SB, New Blade support, LB553S, LB553Se, LC48, LC348V, -VE, -VI, LC53, LC353V, -VE, -VI, LB48, LB348V, -VE, LB448S, LB548Se, 2016-01

A new blade support will be introduced in production and as spare part. The old version could wear out the belt / pulley and cause the belt to slip.

Blade Support Kit (D=83mm)	Kit P/N	Model	PNC
	501 88 32-01	Husqvarna LB553S Husqvarna LB553S e	967257101 967257001

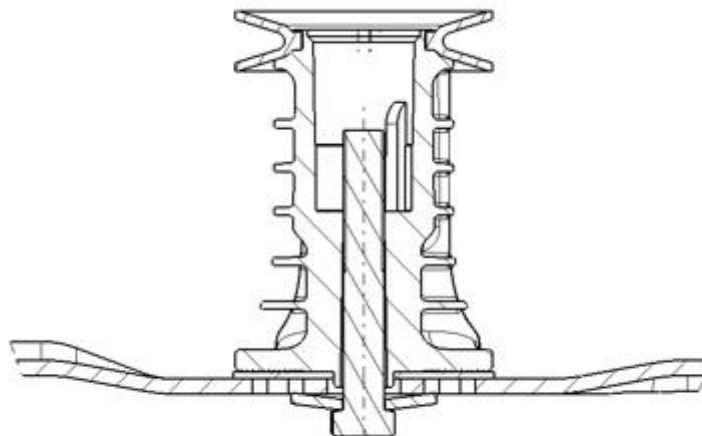
The new LB553 blade support has an integrated pulley with a modified blade attachment which solves the slipping blade issue.

70=Nm

Blade Support Kit (D=60mm)	Kit P/N	Model	PNC
	501 88 29-01	Husqvarna LC48/LC348V, VE, VI	All
	501 88 30-01	Husqvarna LB48/LB348V, VE	All
	501 88 31-01	Husqvarna LC53/LC353V, VE, VI, EE	All (not for BE with BBC)

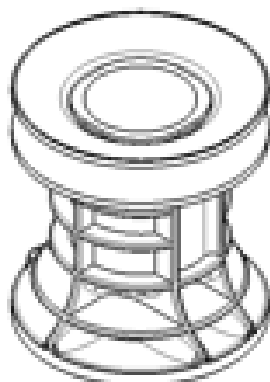
The new blade support is made of a different material (steel pulley) which will solve the wear issue.

70=Nm
